Public Works (1898) Department.

Sub-Registrar's office at Manamadurai in the
Madurai Dist.

—
Estimate of Rs. 4580 for constructing a —
sanctioned with remark

Name of Work *Constructing Sub-Registration*

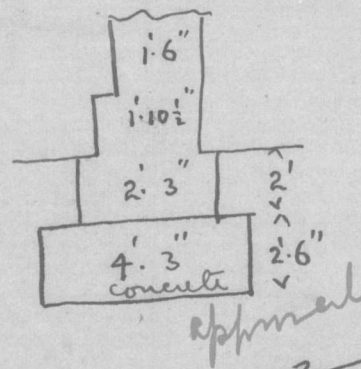
The found. as estimated for seem unnecessarily expensive. The following modification is proposed -

The foundations appear to be unnecessarily expensive for walls only 15 feet high, instead of laying 2 feet of concrete & 4 ft. of brick masonry as proposed, it might be well to substitute 2 feet of sand filling over which 2 ft. of concrete & 2 ft. of masonry above.

height W as
The estimate has been revised
as ordered, viz. the section of foundation
has been altered & granite floor sub.
of finished floor to the second
room.
